Record of Decision
Tappan Terminal Site
Village of Hastings-on-Hudson
Westchester County, New York
3-60-015

DECLARATION STATEMENT - RECORD OF DECISION

Tappan Terminal Inactive Hazardous Waste Disposal Site Village of Hastings-on-Hudson, Westchester County, New York Site No. 3-60-015

FIGURE 6

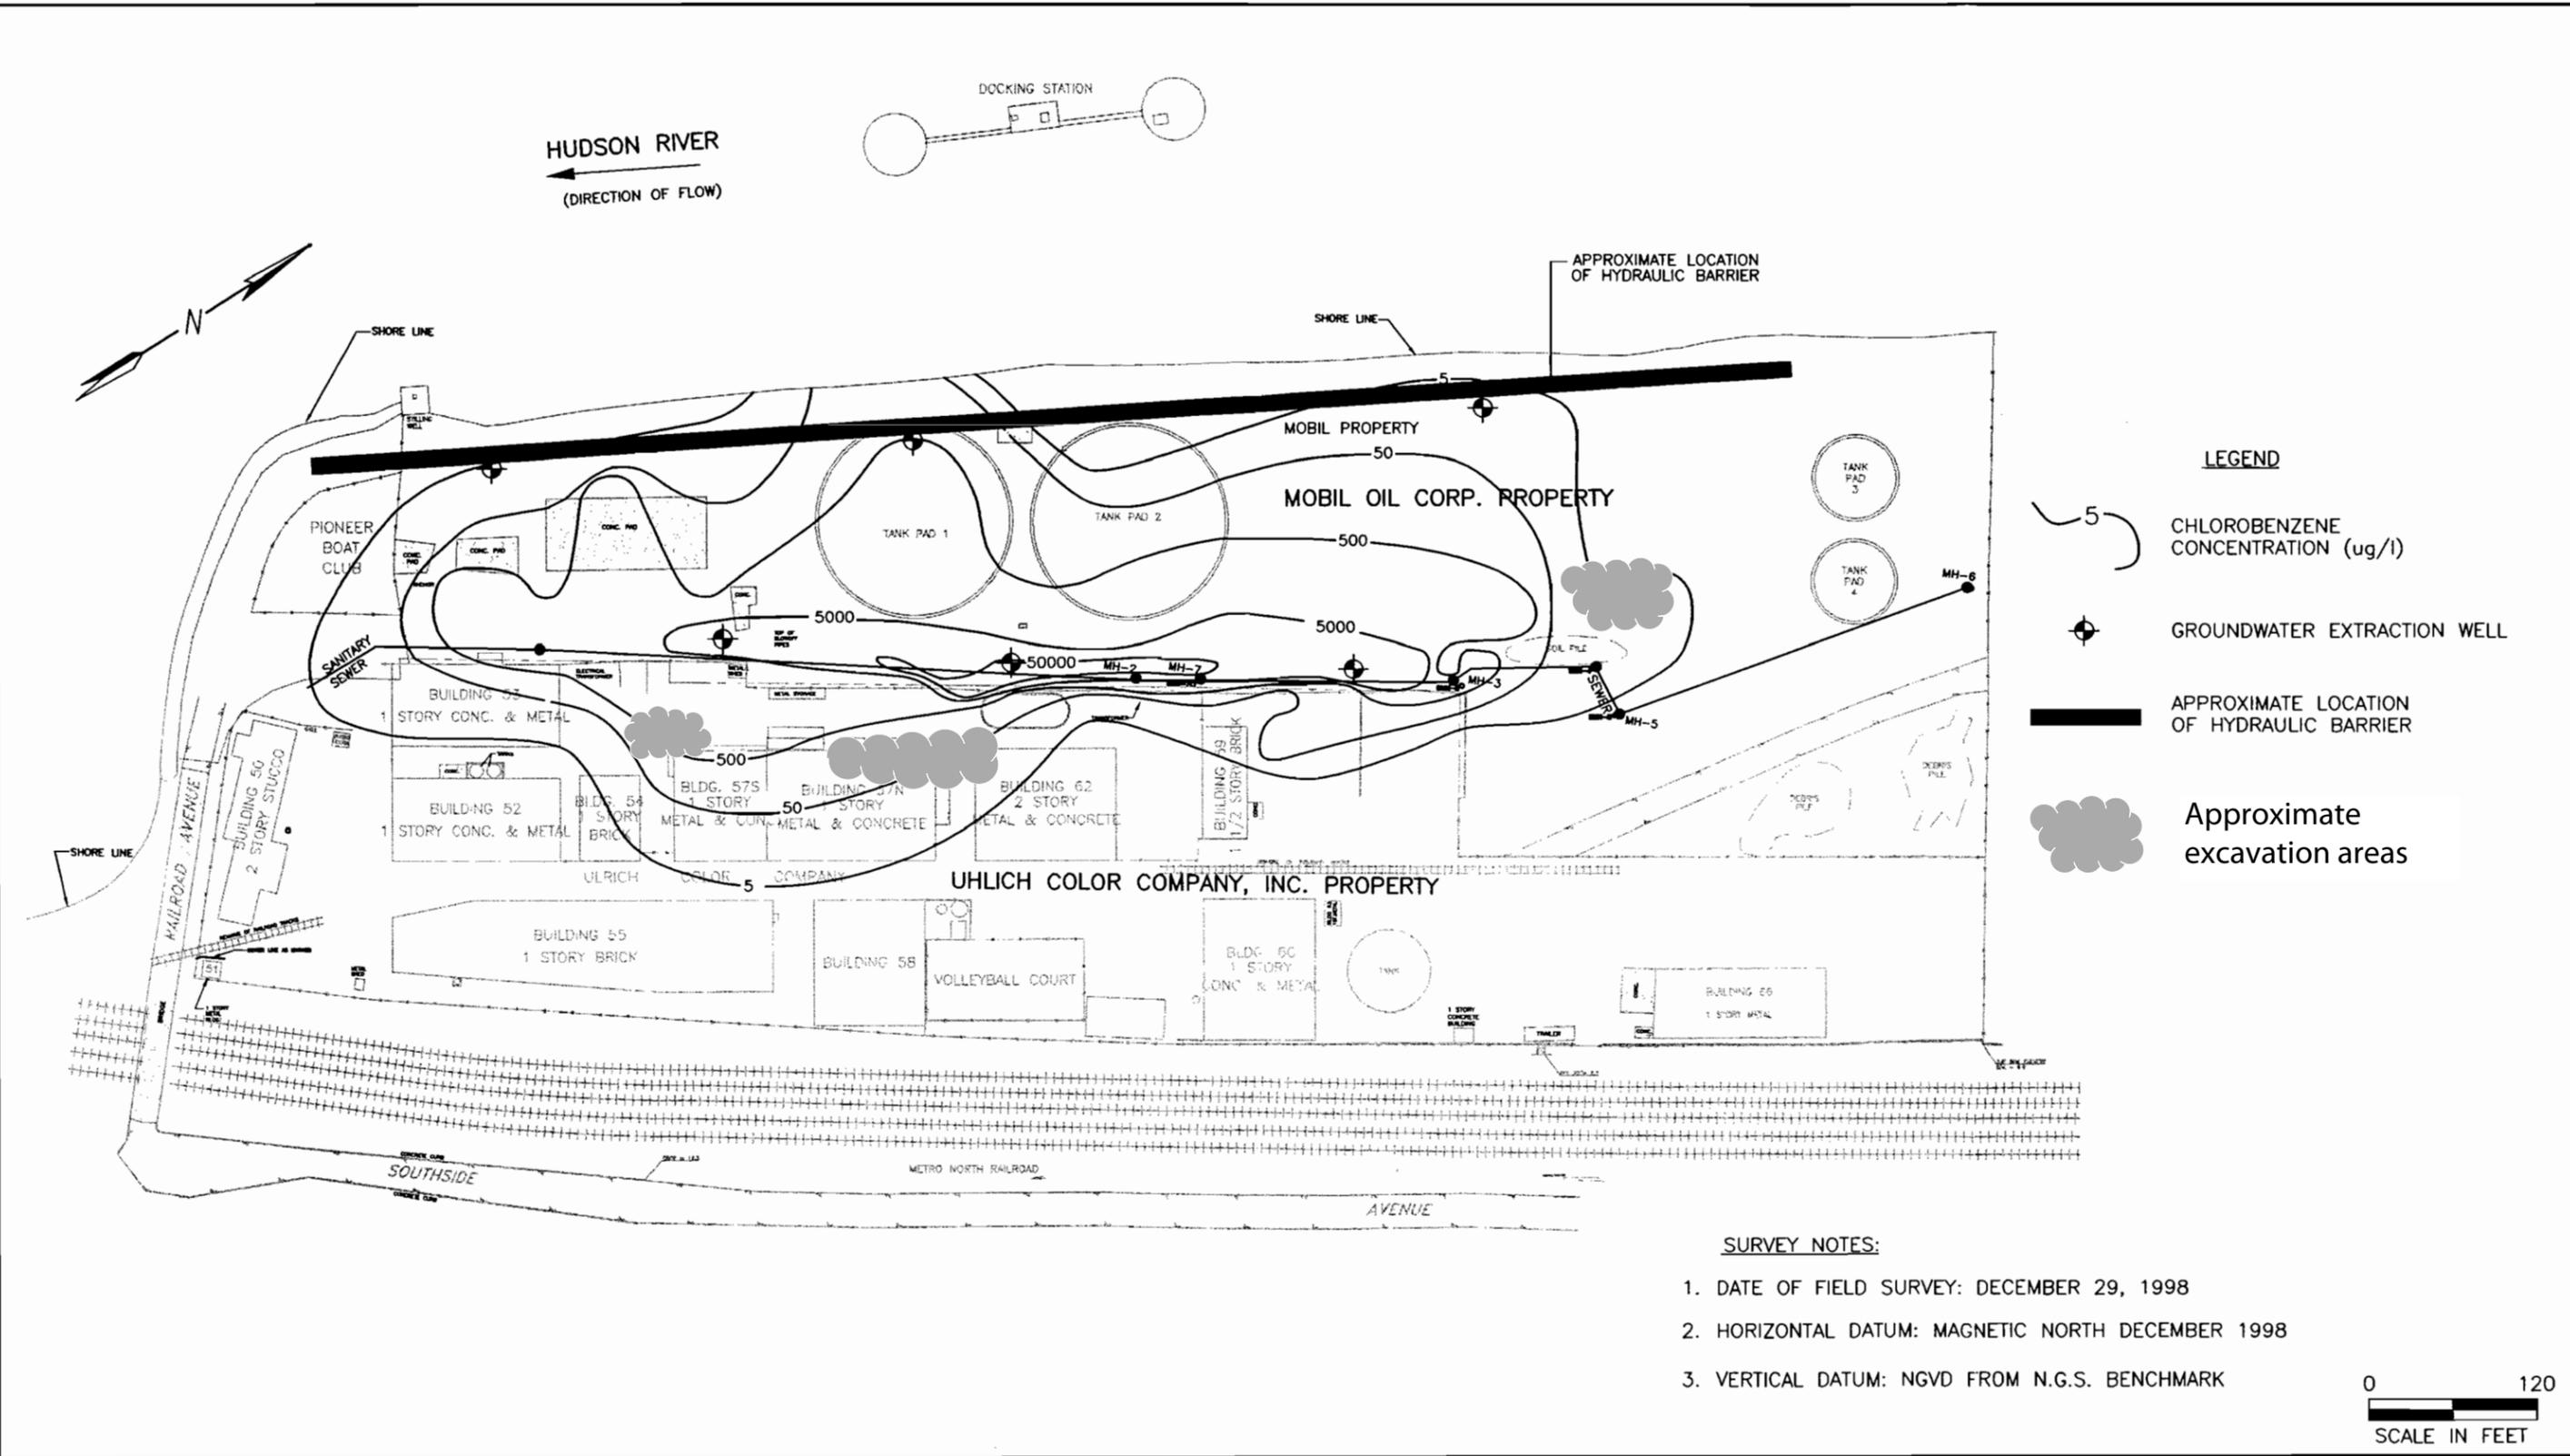
Comment 33: As outlined in the PRAP, the selected soil remedy includes the excavation and off-site disposal of "grossly contaminated soils" related to residual petroleum identified on the former Mobil Tappan Terminal. Figure 6 of the PRAP depicts the proposed location for the completion of this soil excavation. The PRAP does not provide information on the deciding factor in determining grossly contaminated soils or the extent of the area to be evaluated for the presence of grossly contaminated soils.
